## NOTICE OF PROPOSED CHANGE IN PROPERTY

PETITION NO. 374 GENERAL DEVELOPMENT COMPANY LLC C/O CHRYSLER CORPORATION TWO TOWER SQUARE, SUITE 850 SOUTHFIELD, MICHIGAN 48078 C/O BRUCE BRICKMAN PHONE NO. 248 514-7111

## - REQUESTED CONVERSION TO EASEMENT

B DESCRIPTION REVI	ORWN CHKD APPD DATE	A PORTION OF SCOTTEN AVE. 780 FT. 66 FT. WD. IN THE BLOCK BOUND BY CLARK, MICHIGAN AVE., MICHIGAN CENTRAL R.R. AND NEW YORK CITY R R		OF DETROIT SINEERING DEPARTMENT SIRVEY BUREAU
DRAWN BY WLW	CHECKED		JOB NO.	01-01
08-20-14	APPROVED		DRWG. NO.	X 374

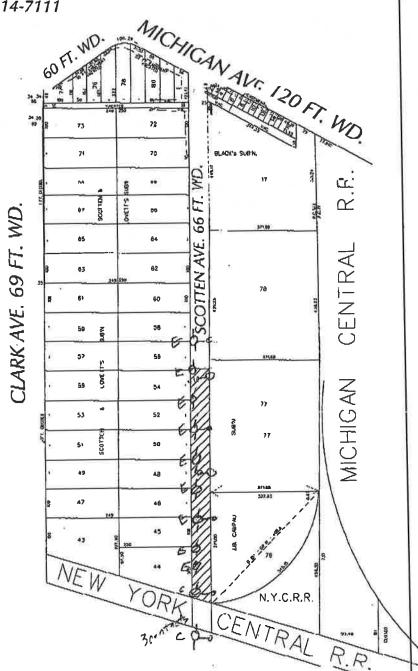
The PLD has an overhead circuit on the DTE pole lead on the West side of Scotten. We do not know if DTE is planning to relocate their poles to accommodate the petitioner.

If the DTE poles are relocated, we must have right-of-way on the new poles. We also have underground cables, conduit and manholes in this area. We require un-obstructed, 24-hour access to the area (and a joint-use key) if it is fenced and gated.

Prior to formally making the street an easement, please have petitioner enter into a relocation agreement (or access agreement) with Denise Williams of the City of Detroit, PLD on 313-267-7216.
